Marquis Lofts

#2013-258

To: Stuart O'Brien, Chair, and Members of the Portland Planning Board
From: Nell Donaldson, Planner
Date: February 11, 2014
Re: **Addendum to Planning Board Report for public hearing on application 2013-258 – 33-35 Lafayette Street**

Marquis Lofts
33-35 Lafayette Street
Level III Site Plan and Subdivision Review
2013-258
Random Orbit, LLC

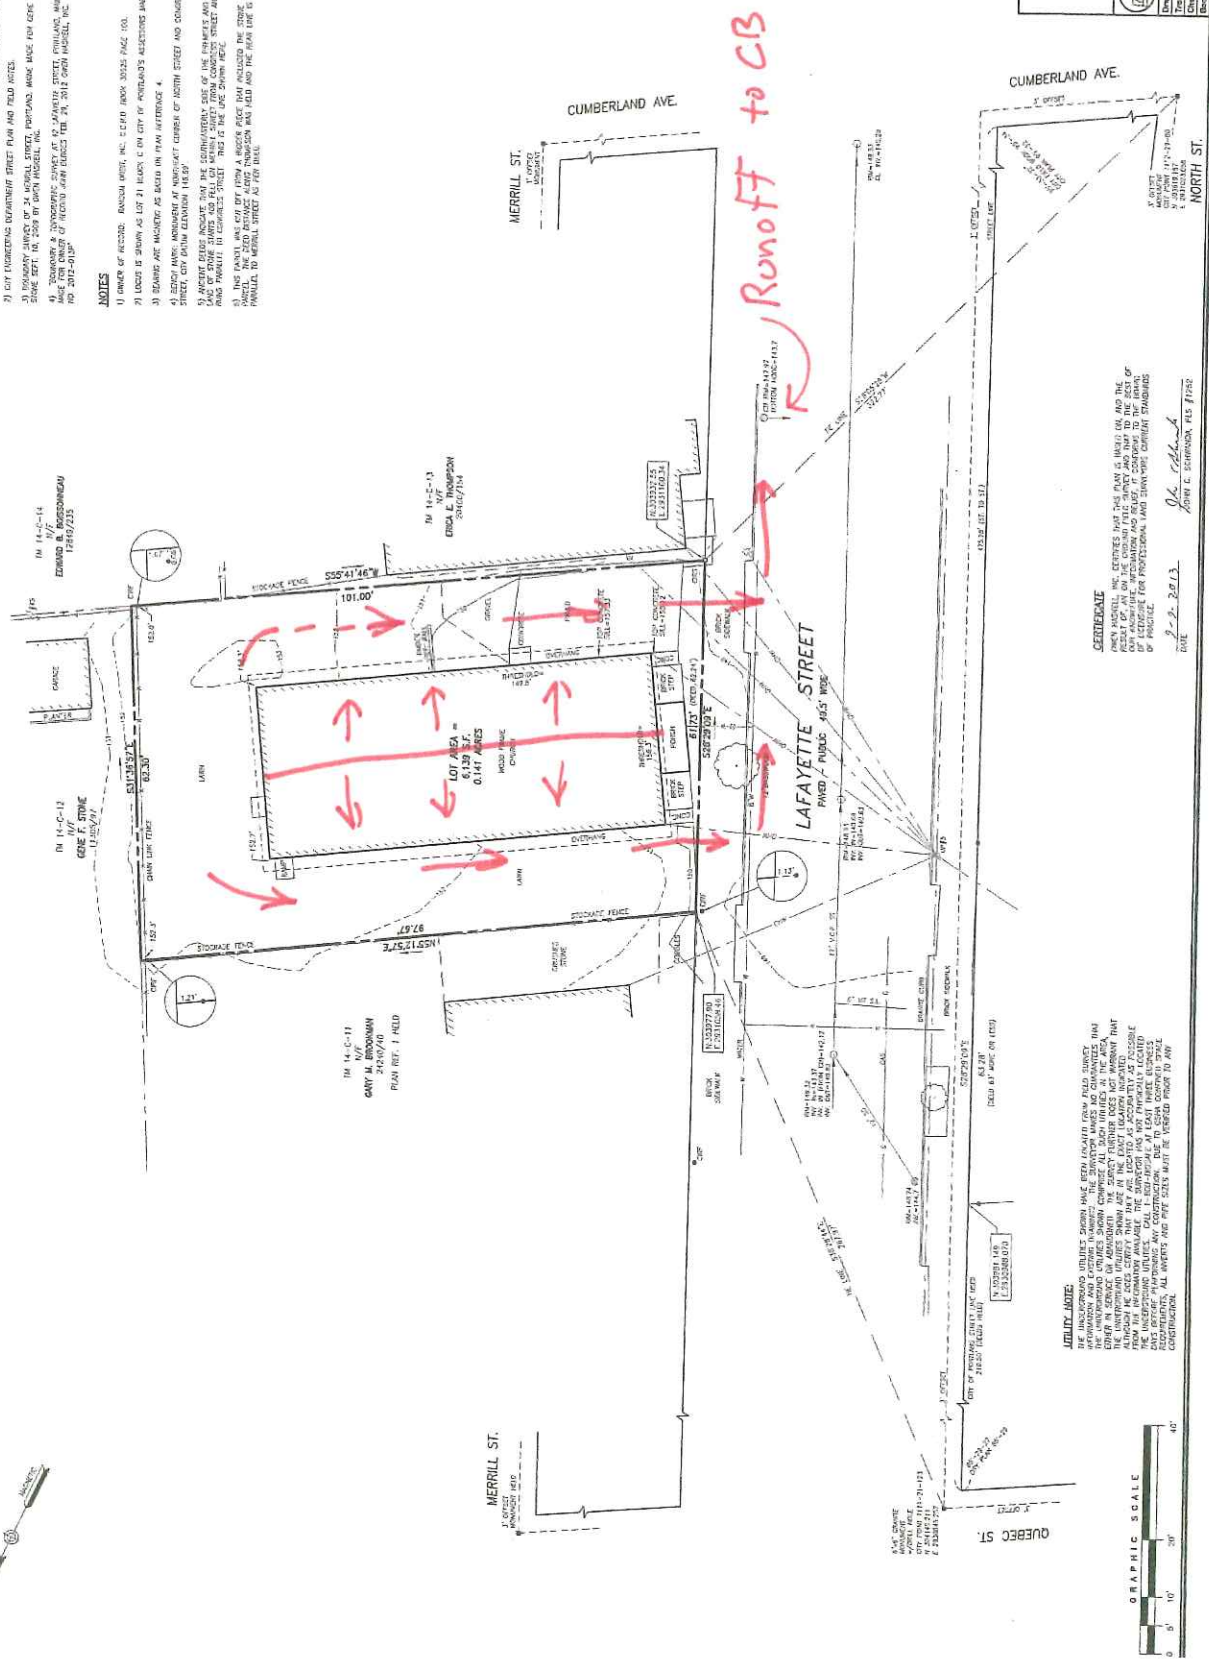
The proposed project is shown on Sheet C-1 with an impervious area summary shown as Note 16. The net increase in impervious area is 532 s.f., which is below the level required by ordinance for detention or treatment in accordance with Chapter 500.
